3 Project changes

Cobbora Coal Project - Preferred Project Report and Response to Submissions

Figure 3.2

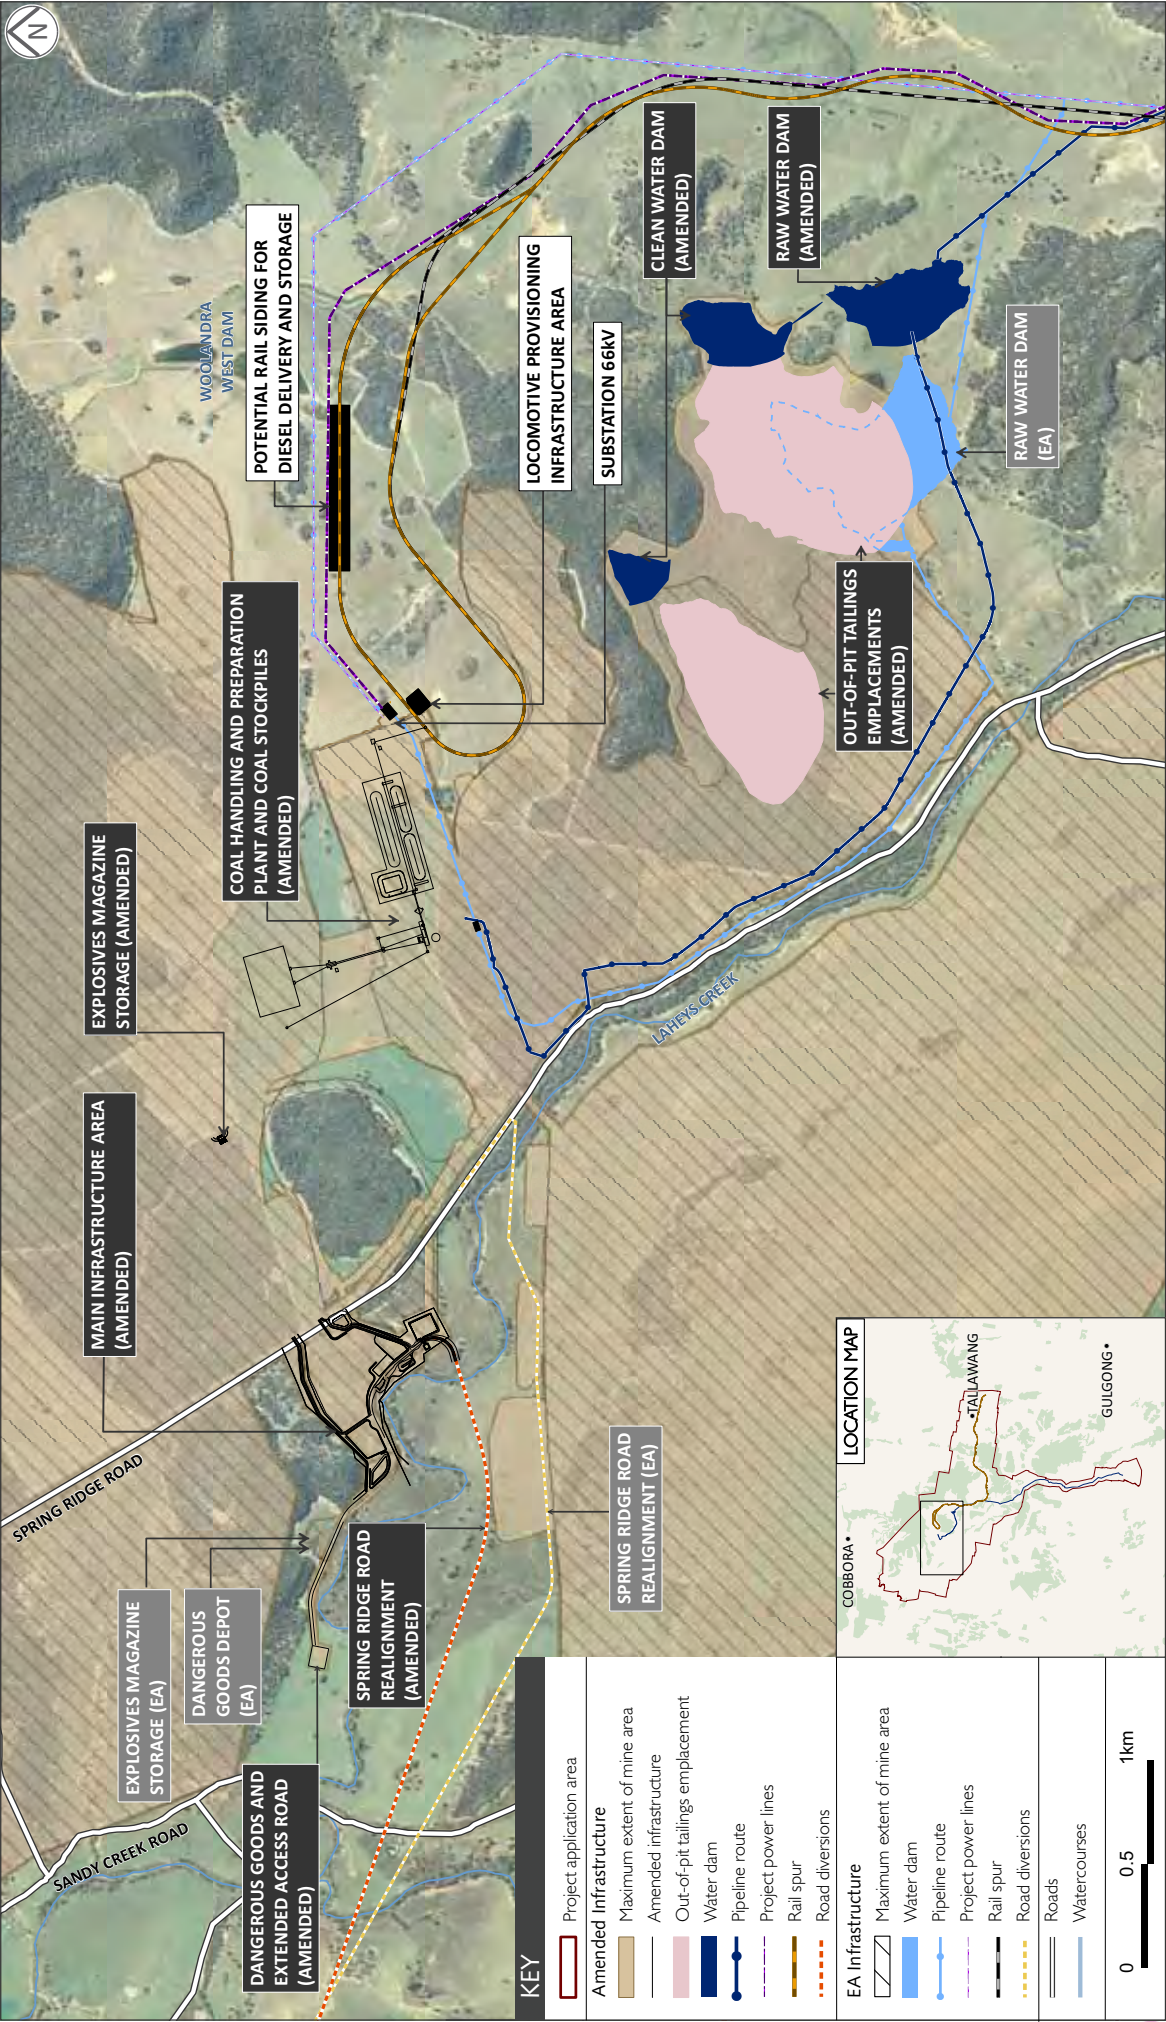
While the total volume of tailings has not changed, it is now proposed to develop two out-of-pit tailings emplacements about 3 km south-east of the MIA and six smaller in-pit emplacements in mining areas A and C (Figure 3.1 and Figure 3.2). The out-of-pit emplacements are still located with the mining areas. The methods used to thicken tailings (Section 3.6.2 of the main EA) and tailings production volumes (Table 3.5 of the main EA) have not changed.

The two out-of-pit tailings emplacements — out-of-pit west and out-of-pit east — will be valley-type emplacements constructed on the existing land surface. Out-of-pit west emplacement will be largely in the original footprint of the B-OOP E waste rock emplacement. Out-of-pit east emplacement will be partly within the area of the previously proposed raw water dam (Figure 3.2).

As the end of the use of out-of-pit tailings emplacements approaches, tailings will be placed in impoundment-type emplacements constructed in mining areas A and C (Figure 3.2).

It is proposed to relocate the raw water dam to an area with greater relief about 800 m to the east of the B-OOP E waste rock emplacement (Figure 3.2). This is to allow the construction of the out-of-pit tailings emplacement east. The capacity of the raw water dam will decrease from about 1.5 GL to about 1 GL and the water surface area when full from about 30 ha to about 17 ha. This will reduce evaporative loss from the dam. The water supply pipeline routes around the dam will be altered to avoid out-of-pit tailings emplacement east.

The B-OOP E waste rock emplacement footprint and height were modified so the out-of-pit tailings emplacement could be developed. The waste rock emplacement will be constructed on three sides of the out-of-pit west tailings emplacement (Figure 3.2). The maximum height of the waste rock emplacement will increase from 430 m to 450 m (above sea level). It is proposed to add an additional area (about 18 ha) to the south-east of the emplacement (Figure 3.2) and outside of the footprint assessed in this report. The footprint of this area will be included in ongoing offset area calculations and all other aspects will be managed as described in the EA and this report.

The MIA has been reduced from 37.2 ha to 33.5 ha (Figure 3.2). This avoids areas in the south, but moves the northern boundary of the MIA about 70 m north. The locations of sedimentation dams associated with the MIA reflect these changes.

Pipeline Route

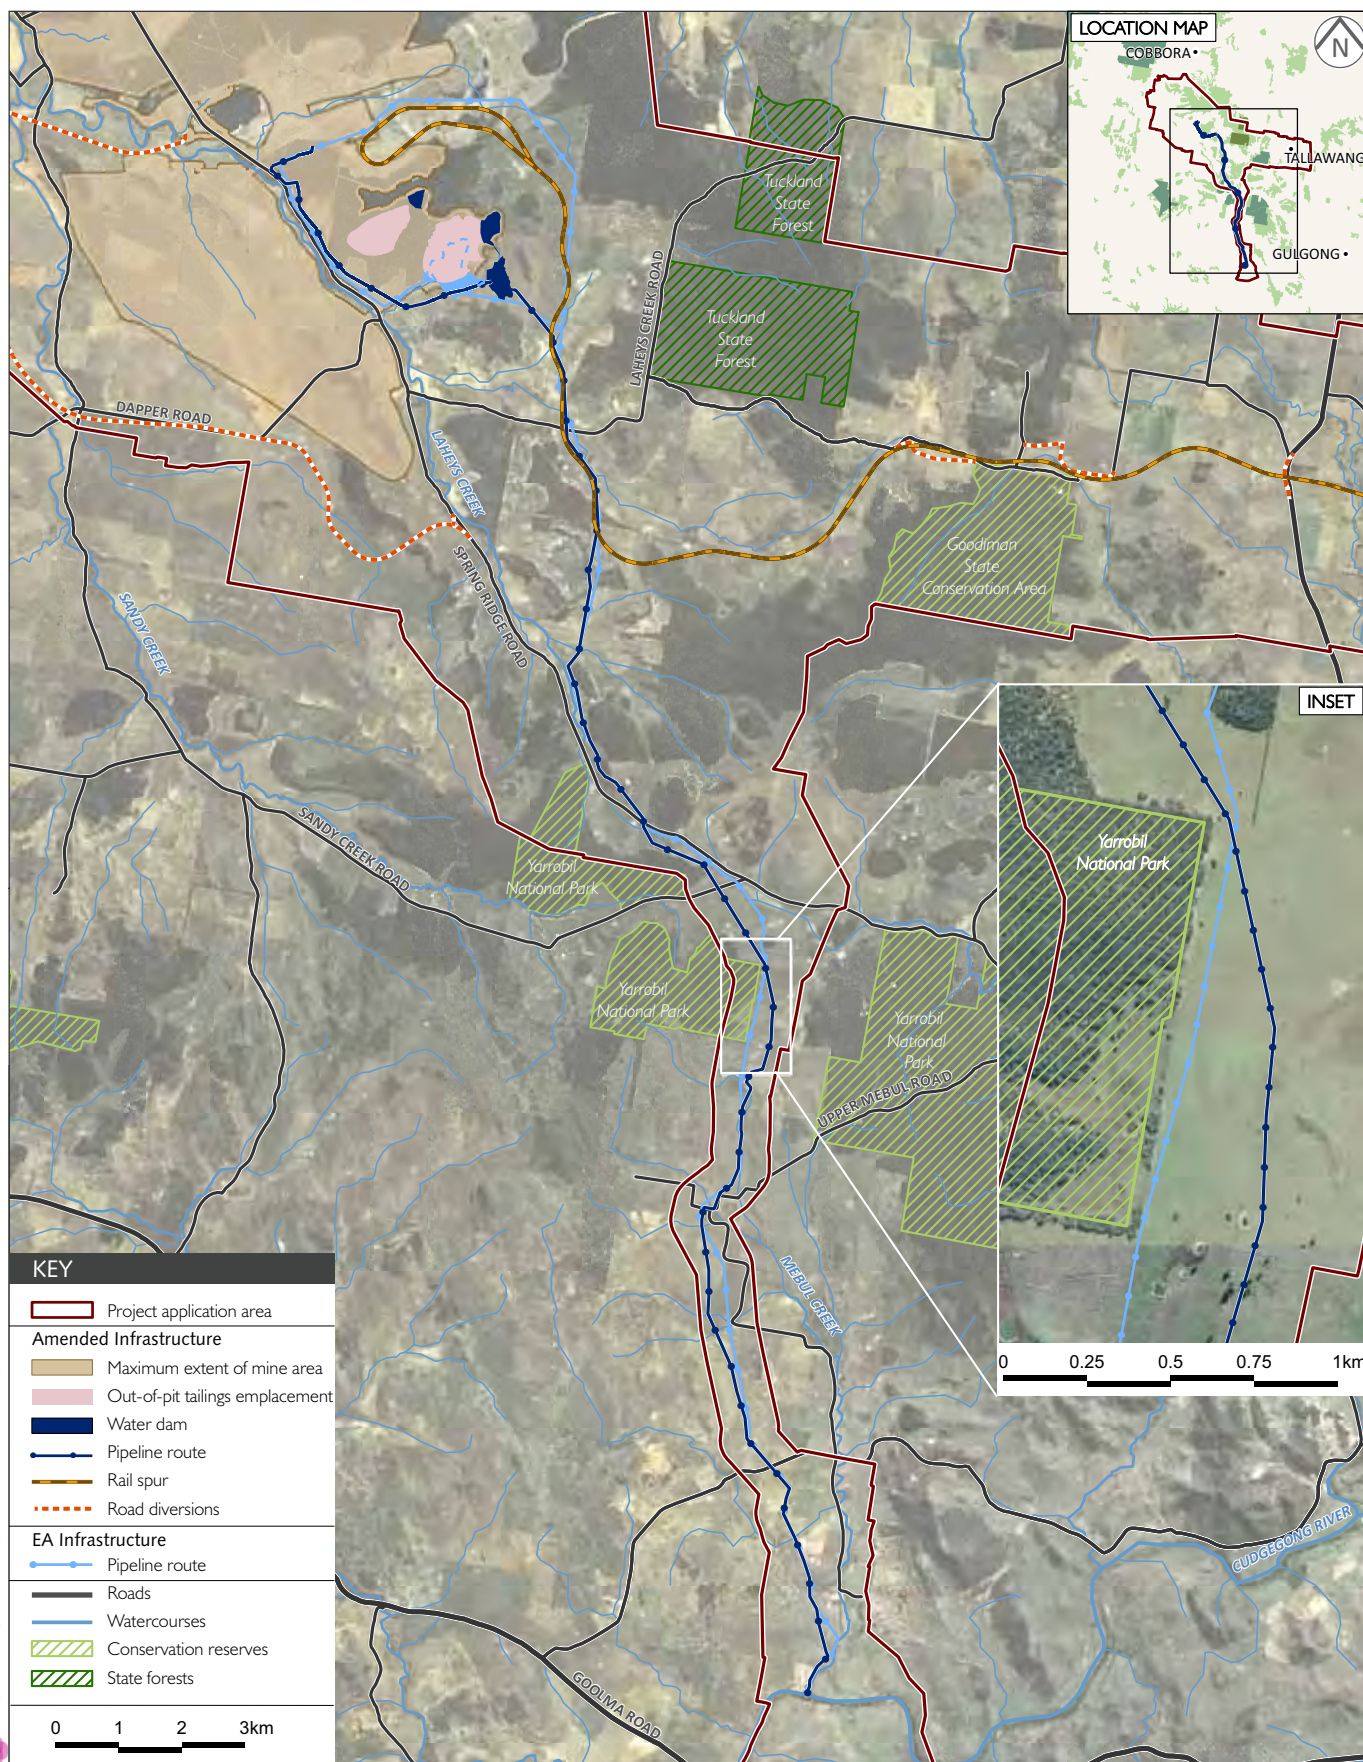
The water pipeline route has been refined to generally provide a greater buffer (40 to 400 m) to the western boundary of Yarrobil National Park and to further avoid patches of vegetation. Along the 26 km long water supply pipeline, the maximum lateral change is 350 m (Figure 3.13).

Rail Spur
Cobbora Coal Project - Preferred Project Report and Response to Submissions
Figure 3.14

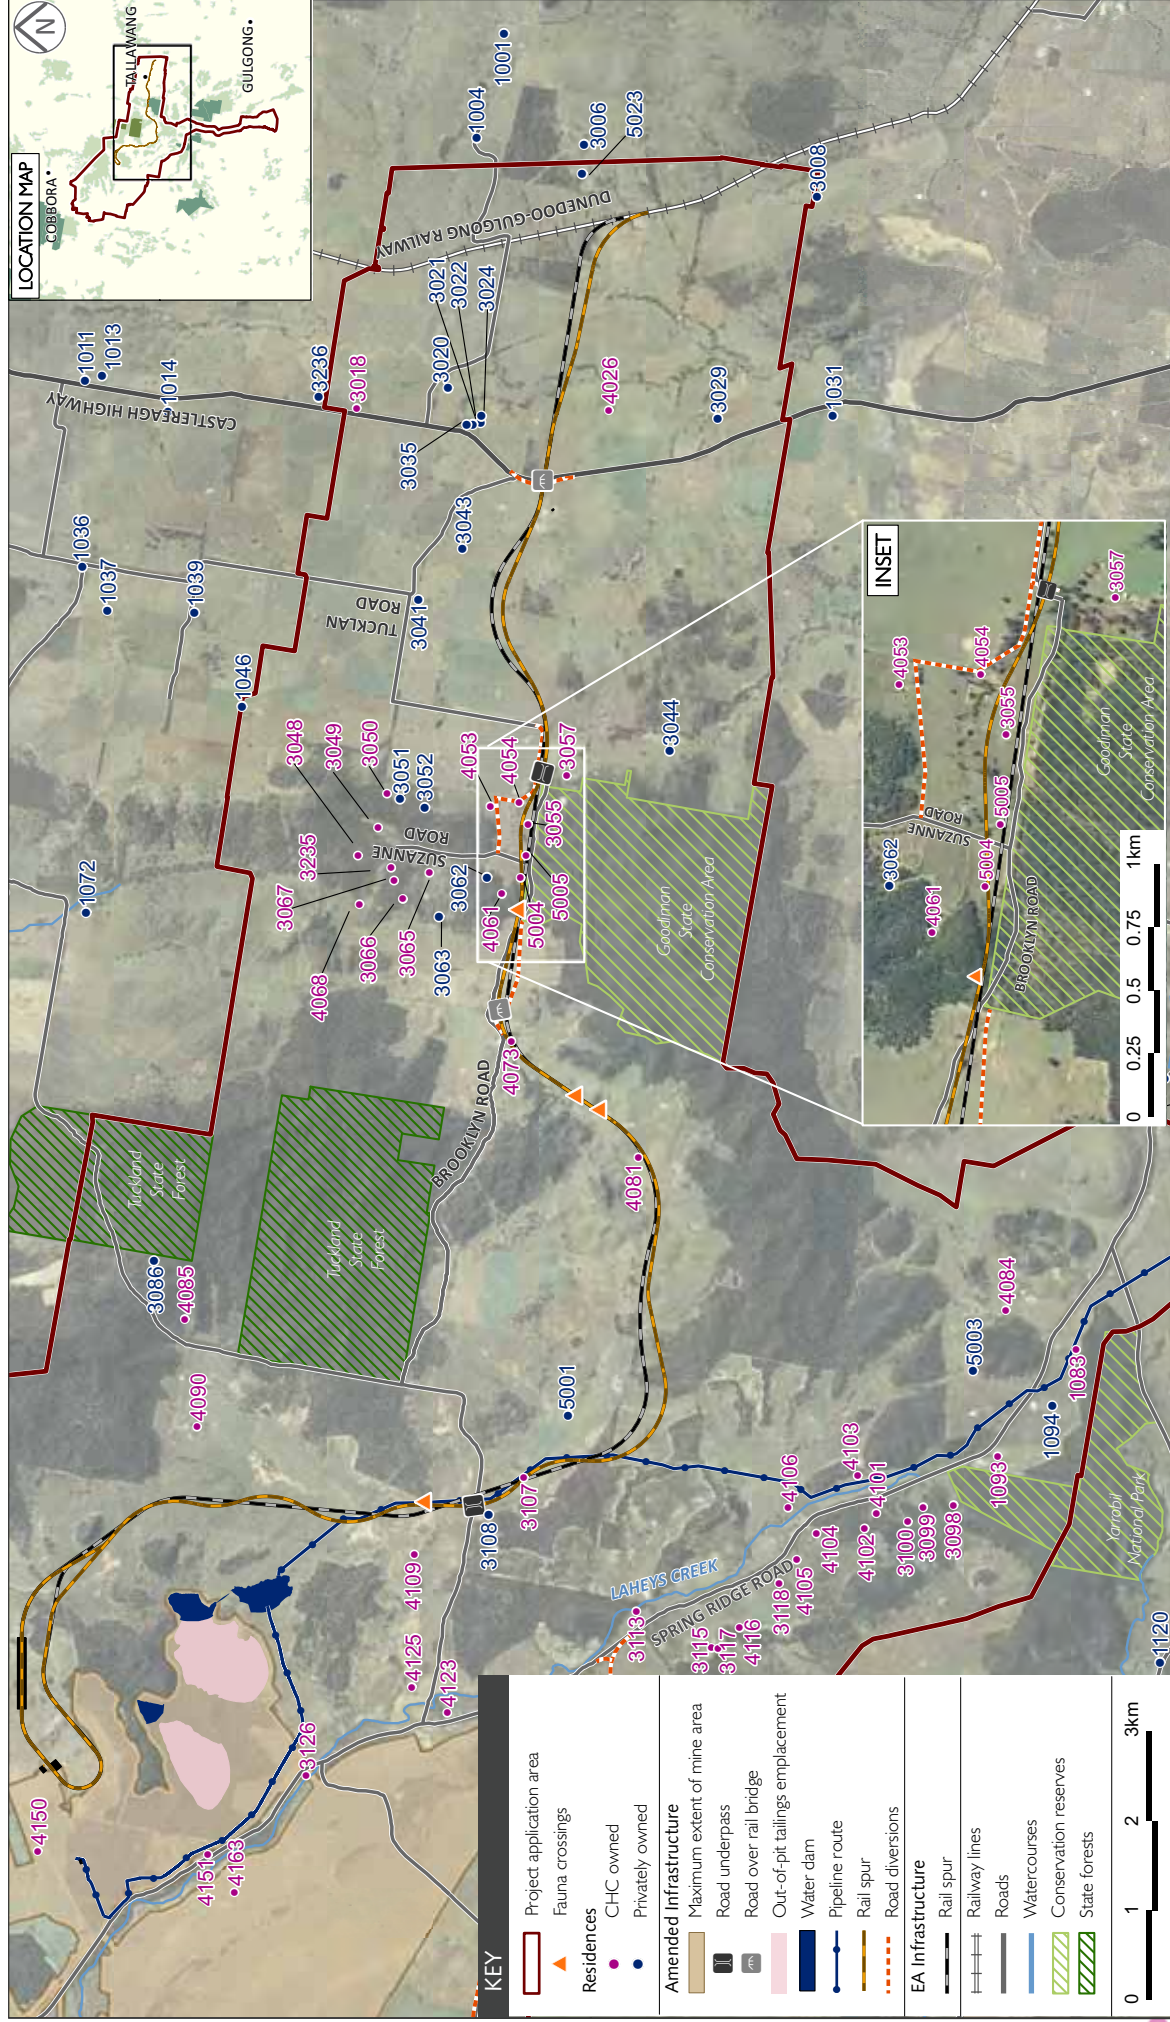
The layout of the rail spur is shown in Figure 3.12 of the main EA. The alignment has been refined to reduce the cuttings depth and embankment heights, which will reduce its overall footprint, improve the efficiency of train operations and decrease fuel use. Along the 28-km long rail spur, the maximum lateral change is 250 m (Figure 3.14).

Figure 3.15

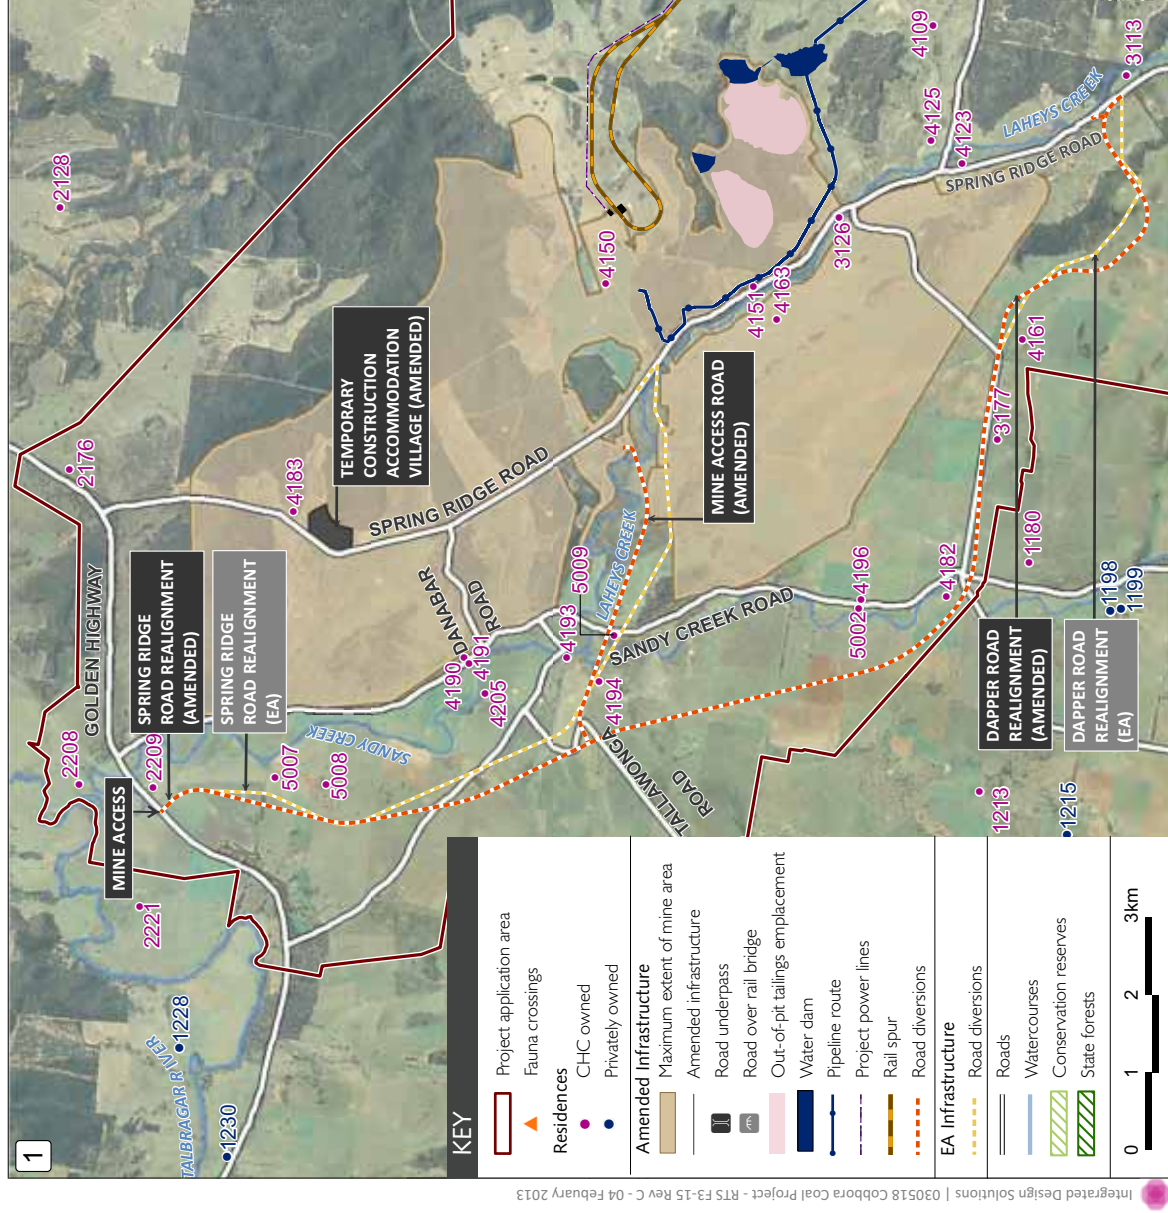
It is now proposed to join the Spring Ridge Road and Dapper Road diversions (Figure 3.15) during the construction phase to provide an entirely sealed diversion road to allow a speed limit of 100 km/h. This longer diversion will generally follow the same route as the Spring Ridge Road diversion between the Golden Highway and Tallawonga Road. It will then continue south across CHC-owned agricultural land before joining an upgraded section of Sandy Creek Road. On reaching the western end of Dapper Road, it will generally follow the route of the previously proposed Dapper Road diversion to join Spring Ridge Road south of mining area B. The amended Spring Ridge Road diversion will be 19 km long.

It is proposed to refine the diversion of Brooklyn Road in the area of Suzanne Road as a result of the modified rail spur route (Figure 3.15). Through traffic travelling east from Corishs Lane to Brooklyn Road and beyond will pass under the rail spur through an underpass on the west side of Goodiman SCA. This will join the existing Brooklyn Road running on the north of, and in parts through, Goodiman SCA. A new section of road and a road over rail bridge will take Brooklyn Road over the rail spur and back onto its exiting alignment.
